PLANNING REPORT

ARCHITECTURAL REVIEW BOARD

Wednesday, February 21, 2024

16-22 N.HIGH STREET DEMOLITION/BACKGROUND and CONCEPT PLAN 23-136DEMO, 23-135CP

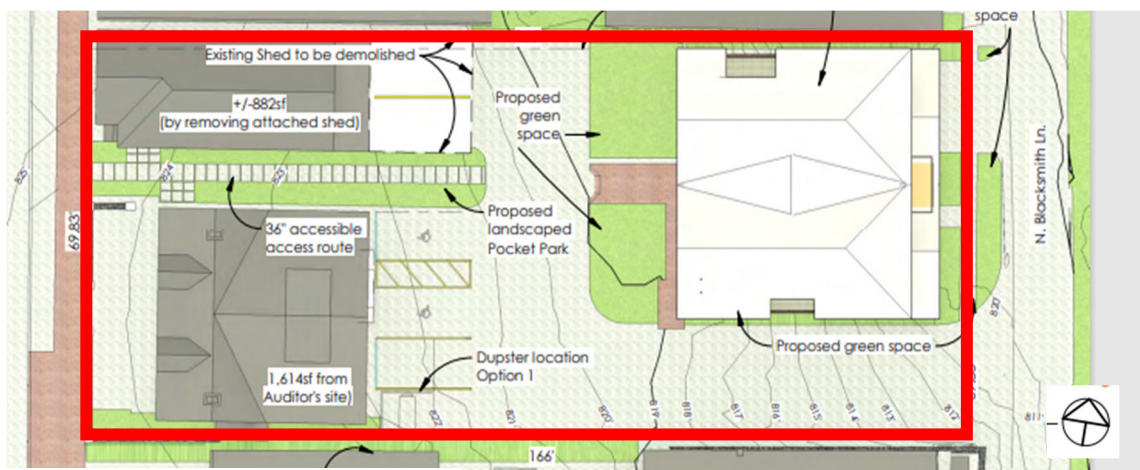
Despite the building height and scale reduction, staff remains concerned with the building architecture. The symmetrical double gables create a feeling of row housing and do not respond to the intended use of the building, although they do serve to help break up the mass of the building. Staff recommends architectural changes, including incorporating elements that respond to the intended use. The window organization creates a monotonous façade, contrary to guidance in Section 5 of the Guidelines. Both 16 N. High Street and 22 N. High Street have

- 1) At PDP, the Applicant shall address form, windows, and door openings, in both size and location, to better address the intent of the Guidelines.
- 2) At PDP, the applicant shall explore a pedestrian connection from Blacksmith Lane to the proposed pocket park; a location for bike racks shall be considered.
- 3) At PDP, the applicant shall consider expanding the pocket park towards the north property line, in lieu of the proposed parking spaces which would create maneuverability concerns.
- 4) At PDP, the applicant shall address Building Standard comments, noting that building form and use arrangement may be affected.
- 5) At PDP, the applicant shall provide a site plan showing all existing sanitary laterals and provide a Water Service Plan to Dublin and the City of Columbus Division of Water for review.

Views along N. Blacksmith Ln

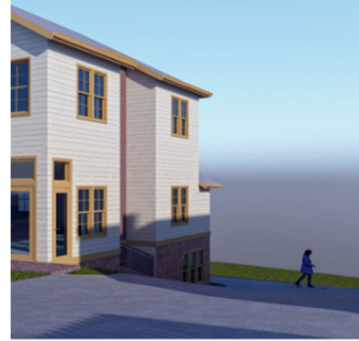
Staff recommends architectural changes on the façade to respond to the proposed restaurant use, creating more light and views from the proposed restaurant. The deck at the topmost floor and the first-floor roofing can be modified, allowing for a larger deck. Additionally, staff recommends breaking the repetitive front gable roof and creating architecturally responsive patterns. Similar to the N. High Street façade, the architecture, openings, and deck do not respond to the character of the Historic District and must be addressed at the PDP. These are included as a recommended condition of approval.
